Your Ref
APP/14/00035
Our Ref
PLAN-005273
Date
03/02/2014

**Proposal: Two storey extension to existing end of terrace house to create 1No.
2 bed dwelling utilising existing vehicular access to Winchfield Crescent.
Site: 1 Winchfield Crescent, Havant, PO9 3SP.
APP/14/00035**

Screen Print

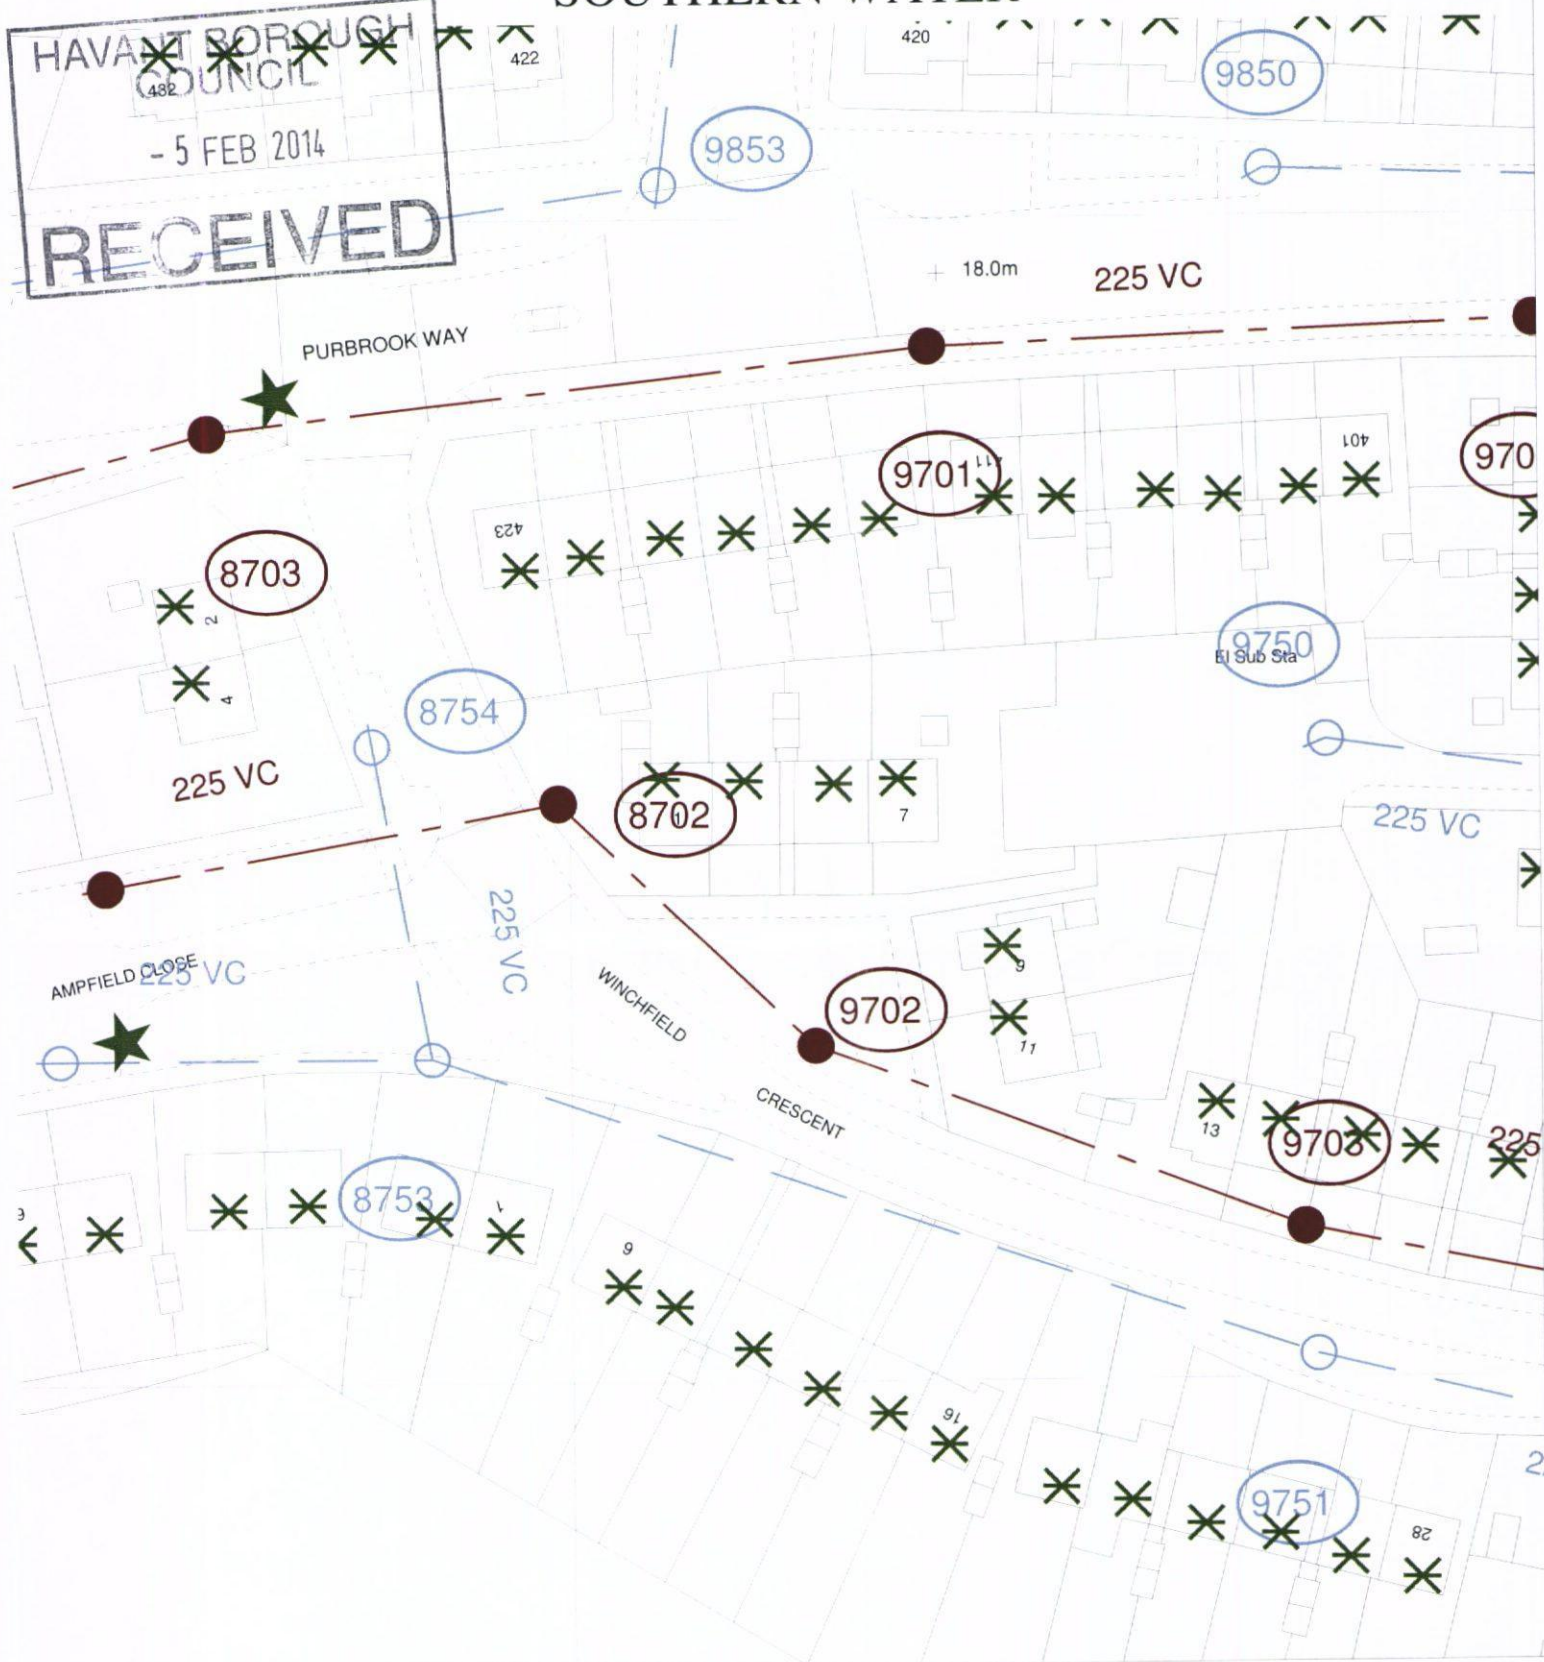
Please find attached a plan of the sewer records showing the approximate position of public sewers crossing the site. The exact position of the public sewers must be determined on site by the applicant before the layout of the proposed development is finalised. Furthermore, the sewer running from North-West corner is now deemed as public sewer, due to changes in legislation that came in to force on 1st October 2011. If planning permission were to be granted, Southern Water (as the statutory sewerage undertaker) would request that the Council (as the Building Control Authority) refuse Building Regulations approval on the grounds that building over the public sewer cannot be permitted.

In order to progress the proposed development on the site, the sewers will have to be diverted away from the line of the proposed dwelling or amend the plans so that the sewers are not constructed over.

1. The sewers requires a clearance of 3 metres either side of the sewer to protect it from construction works and allow for future access for maintenance.
2. No development or new tree planting should be located within 3 metres either side of the centreline of the public sewer
3. No new soakaways should be located within 5 metres of a public sewer.
4. All other existing infrastructure should be protected during the course of construction works.

In order to protect drainage apparatus, Southern Water requests that if consent is granted, a condition is attached to the planning permission. For example "The developer must advise the local authority (in consultation with Southern Water) of the measures which will be undertaken to divert the public sewers, prior to the commencement of the development."
